**SUBJECT:**          Request to Accept New Material under the 24 Hour Exception Provision  
                            of the Better Government Ordinance

The attached *Sunlight Analysis* for the Lawson Road residence in Kensington related to County File #DP15-3030 (Item D.4) was received after the issuance of the staff report. We respectfully request that you accept these additional public comments for consideration.

## Issue No. 2

Section through Luk House and Proposed Tong-Dean House.  
 1" = 5' - 0"

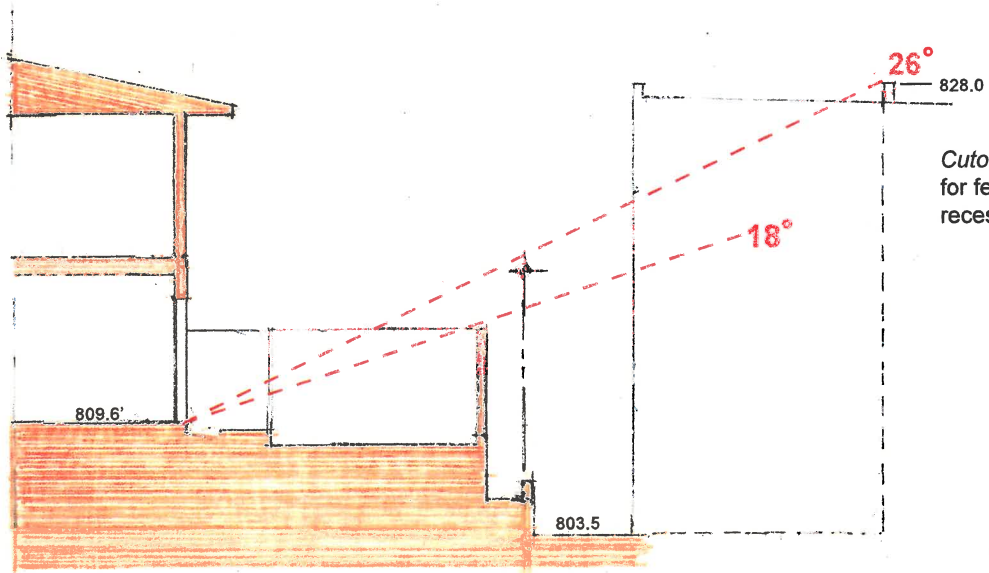
Diagram 3: Section through the Luk house at the Glass Door, showing the solar cutoff angles for the fence around the terrace and the proposed house. The cutoff angles are shown for *full sun* on the Glass Door and for *partial sun* on the Glass Door. These angles are used in the summary diagrams as the boundaries between full sun, partial sun and fully shaded glass.

Cutoff Angles For full sun on the glass for fence and proposed house in **RED**

Cutoff Angle for partial sun on the glass for the proposed house in **BLUE**.

### Shading Mask for Glass Door — Existing Shading at Site

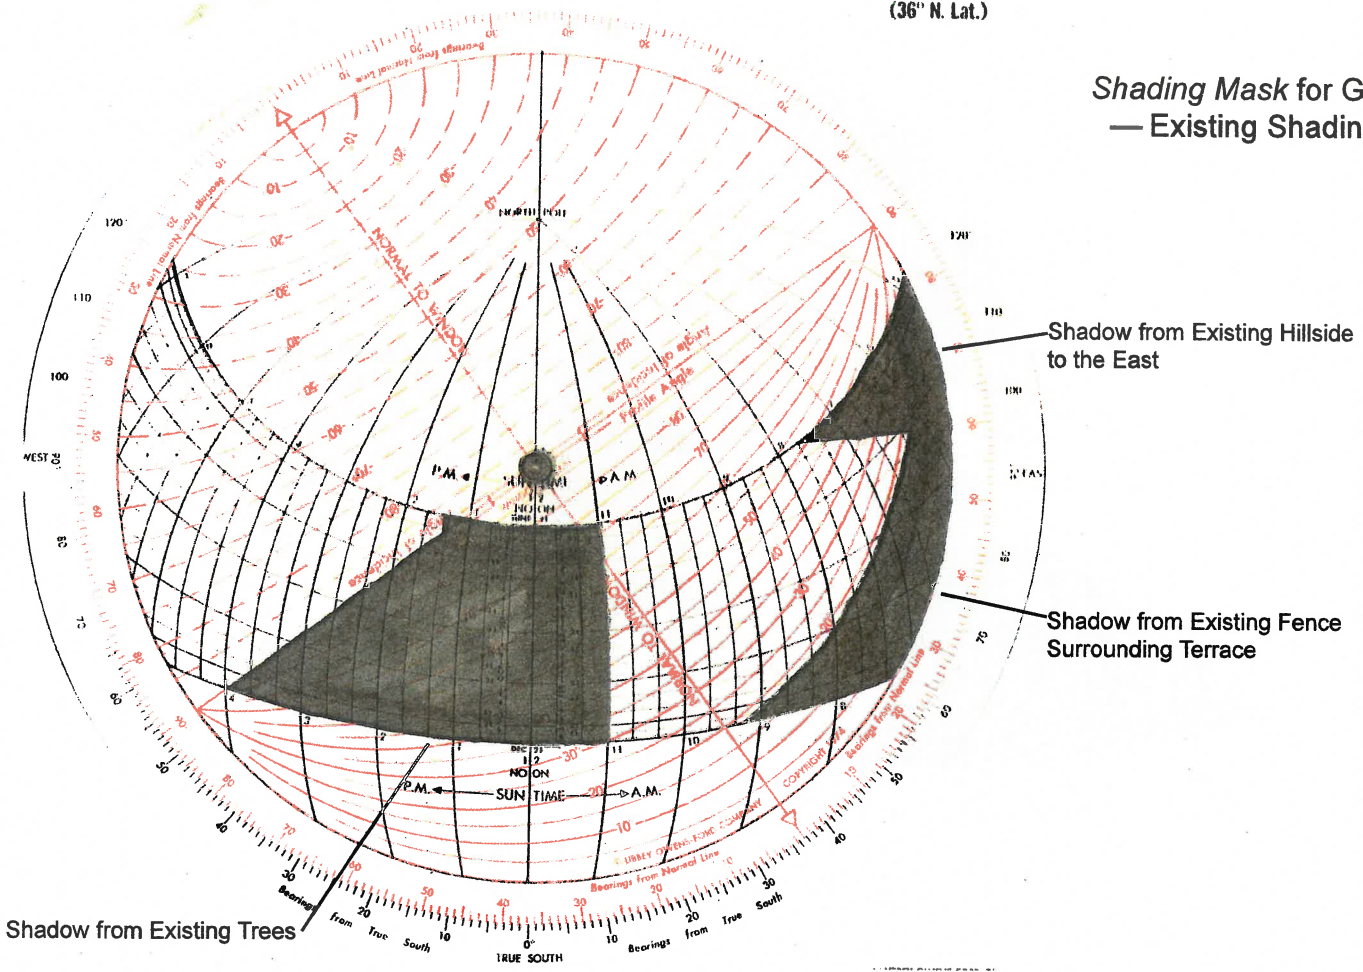
Diagram 5: First of three summary diagrams. This is the *Shading Mask* for the Glass Door under existing conditions. The shadows are from three sources identified in the diagram. The Glass Door receives full sun between 9 AM and 11 AM, starts getting sun blocked in the winter between 8 AM and 9 AM and is blocked between 7 AM and 8 AM for 40% of the year.

### Shading Mask for Glass Door — Effect of Proposed House

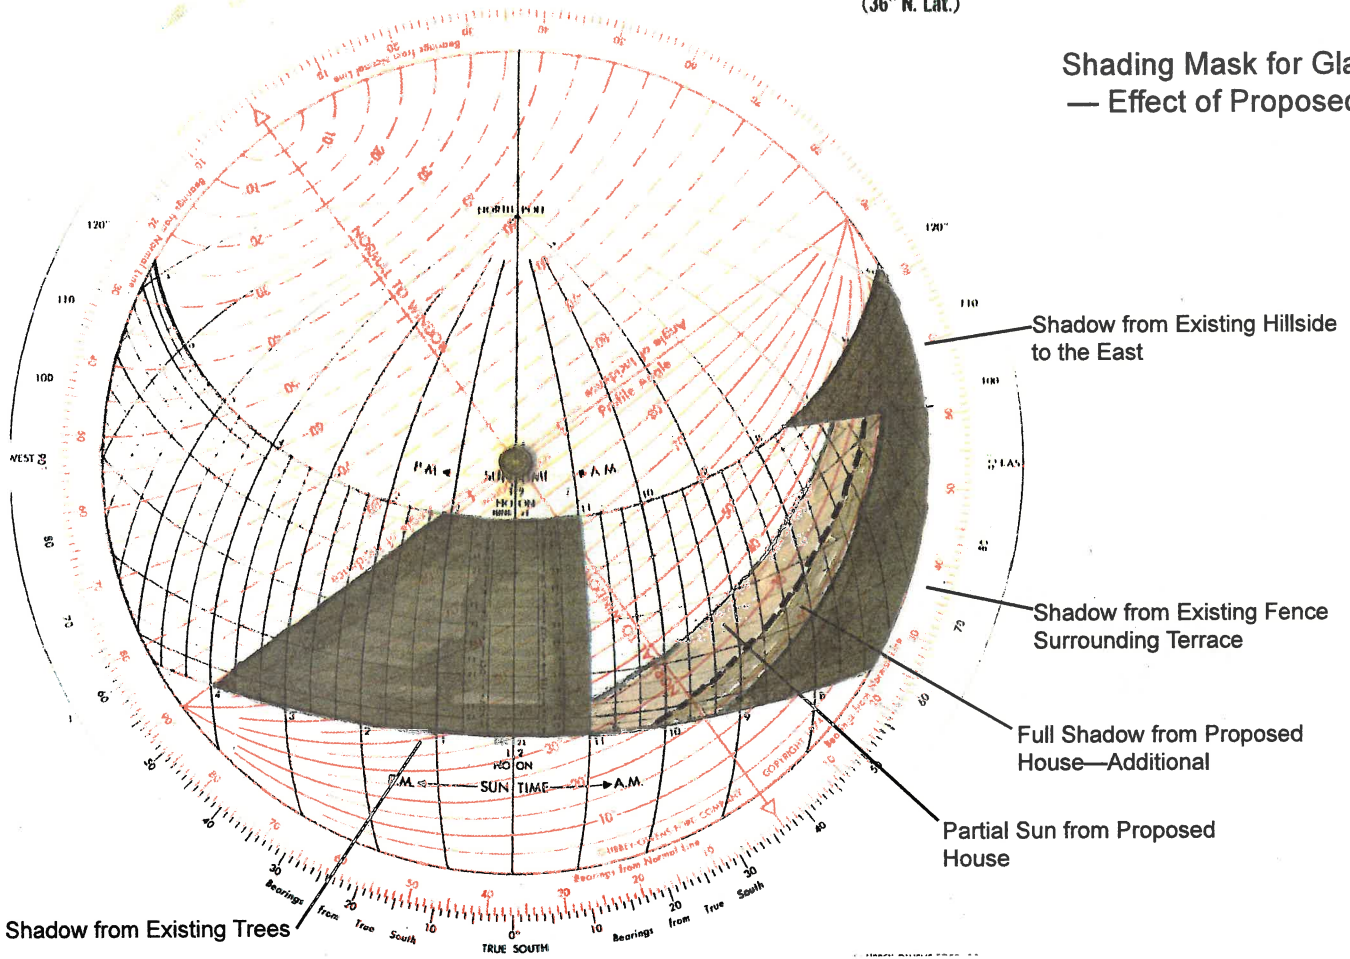
Diagram 6: This diagram shows the effect of the proposed house. There is a small increase in the time of year that full sun is blocked (extension to the dashed line) and further to the time where the Glass Door is partly in sun.

Diagram 6 clearly shows that there is some additional sun blockage in the morning hours but the effect is marginal. In the very early morning hours there is approximately an additional two months of the year where sun is blocked to the Glass Door. In addition, this occurs during the winter when sun angles are low and shadowing is to be expected. (We note again that this is such a marginal effect because the side-yard distance between the houses is 24', not the usual 10' that results from side yard setbacks.)

Nevertheless, we offer a possible mitigation measure, which will be effective in mid-morning hours. By pushing the house back by roughly 5 feet, the recessed garden is more in alignment with the Glass Door, reducing the shading effect for a small amount of time. (See Diagram 7.)
